AGENDA - TROY PLANNING COMMISSION MEETING
WEDNESDAY, MAY 28, 2025, 3:30 P.M.
CITY HALL, COUNCIL CHAMBERS

SUBJECT: Certificate of Appropriateness – 101-103 S. Market Street

SUBJECT: Certificate of Appropriateness – 12-16 S. Market Street

FOX HARBOR SECTION 11
LOCATED IN
CITY OF TROY, MIAMI COUNTY, OHIO
PT. INLOT 7446
7.605 ACRES
MAY 16, 2025

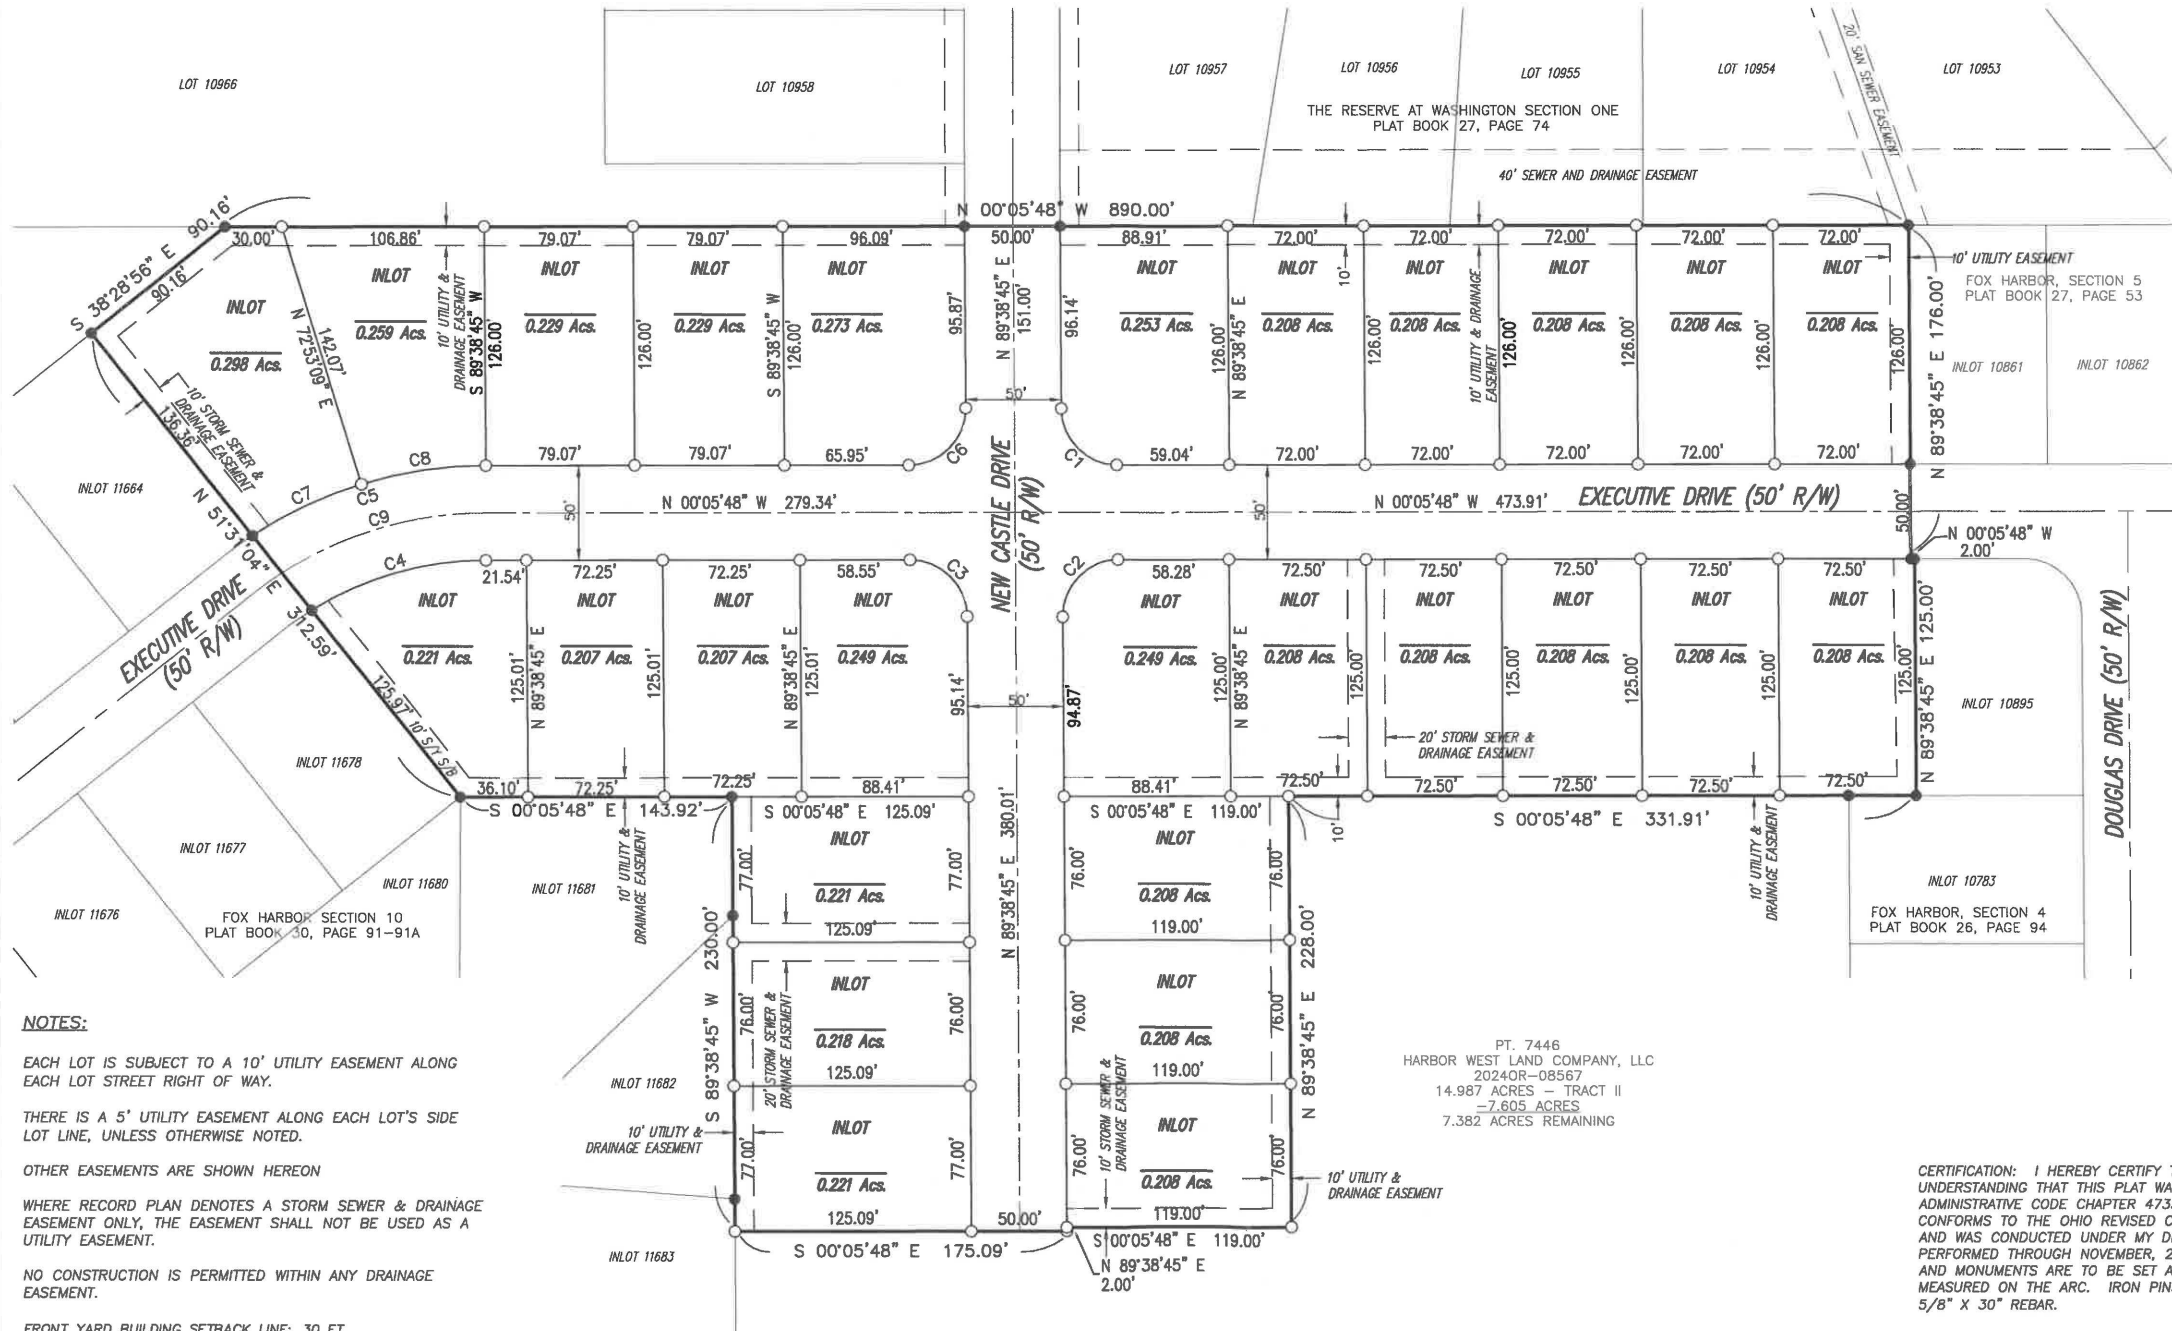
Section 11 encompasses a total of 7.605 acres. There are 27 developable lots on 7.605 acres of land.

The development will dedicate 1.565 acres of public street Right-of-Way. The street names of the roads in this section are New Castle Drive and Executive Drive.

The zoning of this property is R-4 Single-Family Residential which requires a minimum lot size of 9,000 square feet. The proposal indicates the buildable lots range from .207 acres (9,016 square feet) to .298 acres (12,981 square feet).

Staff recommends that Planning Commission provide a positive recommendation to City Council to accept the proposed Final Plat and Dedication of Right-of-Way. As it is in general accordance with the approved Preliminary Plan with the condition that the escrow agreements are provided and accepted prior to going before City Council.
